P 36683
A REPAIR

SEWAGE DISPOSAL SYSTEM
MARYLAND STATE DEPARTMENT OF HEALTH

SUBDIVISION _____ ROAD 3546 Church Road LOT _____

PROPERTY OWNER Frank T. Taylor

PROPOSED
1 STY. FR. ADDITION
36' X 15'

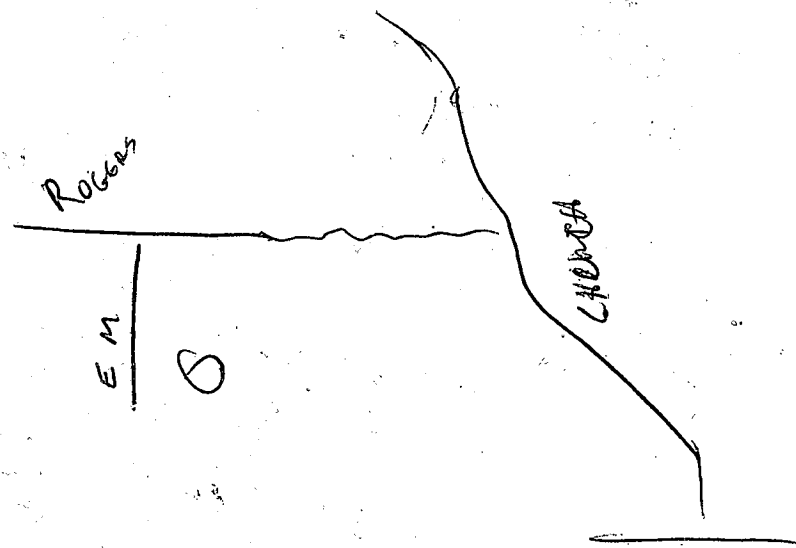
NO EXISTING SEPTIC SYSTEM

SUCCESSFUL PERM.
TANK INSTALLED,
TRENCHES TO BE
ADDED SHORTLY.

OK TO PROCEED *Chandler*

PROPOSED
1 STY. FRAME
ADDITION
36' X 17'

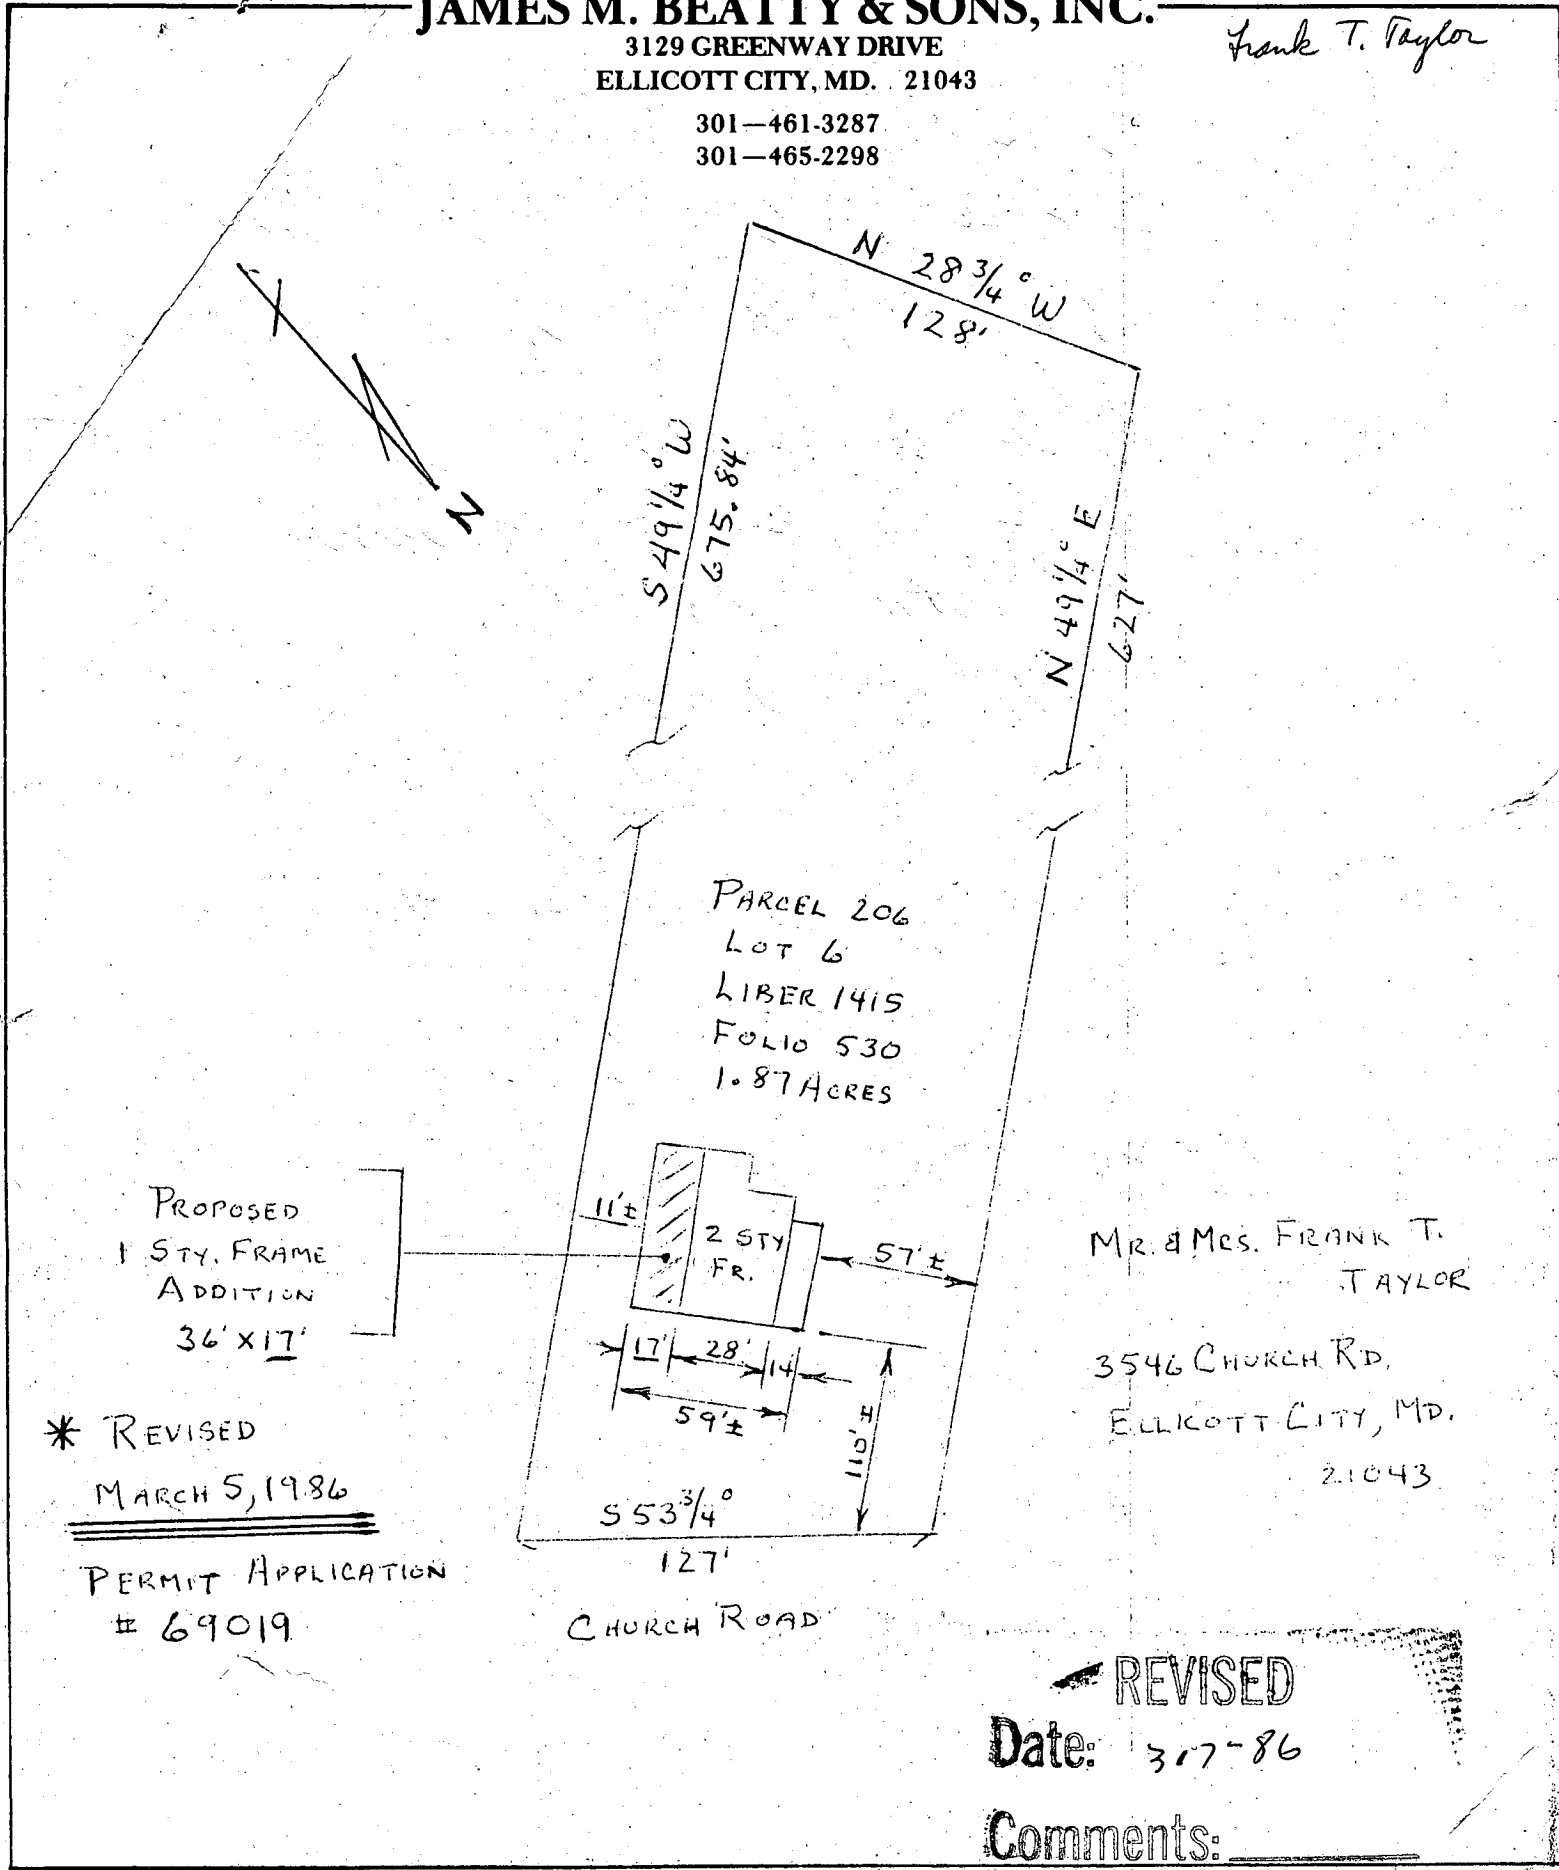
Trench 9 FT deep

± need 2 1/2 FT to 3 FT deep

6 1/2 to 6 ft of Stone 113 FT long

Place Trenches Between the 2
perc Holes lower about 130
ft from The ~~HOUSE~~^{GARAGE} Tank
to be at least 75 ft from The
Well in The Garage

1250 Gal Tank needed 4 BR

& no garbage guard

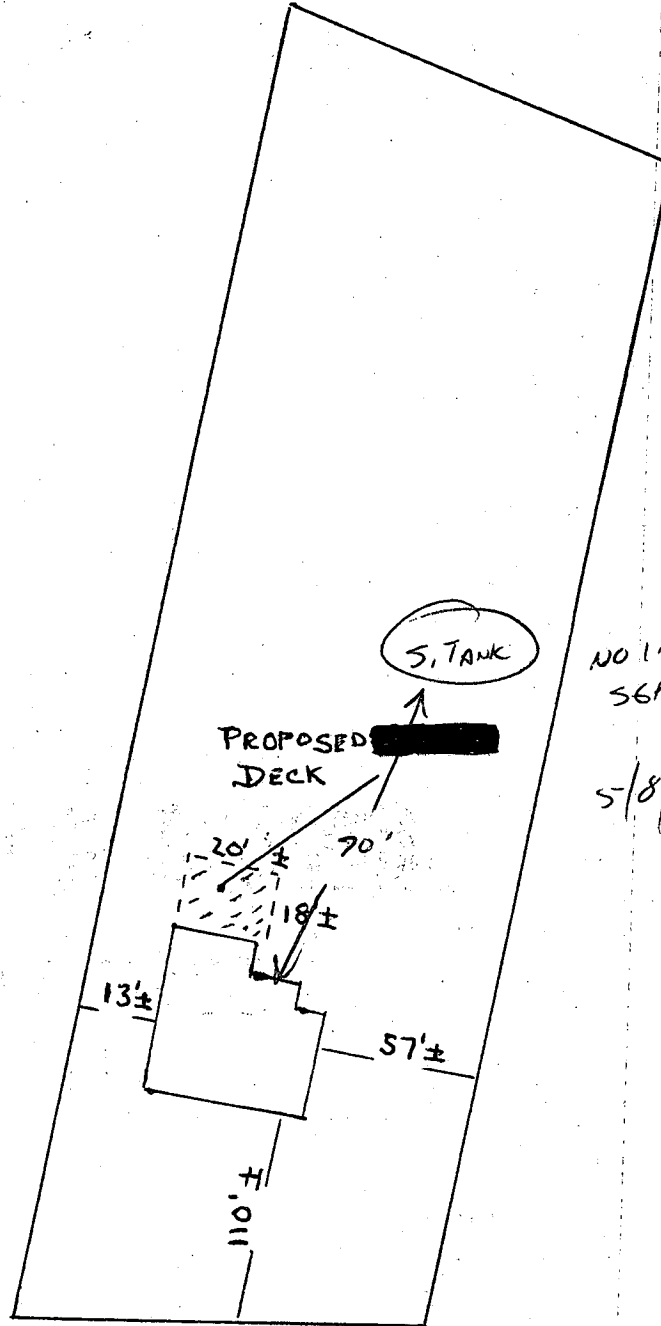
NO IMPACT ON
SEPTIC. OK TO PROCEED
AS DRAWN,
5/8/87 *Chellin*
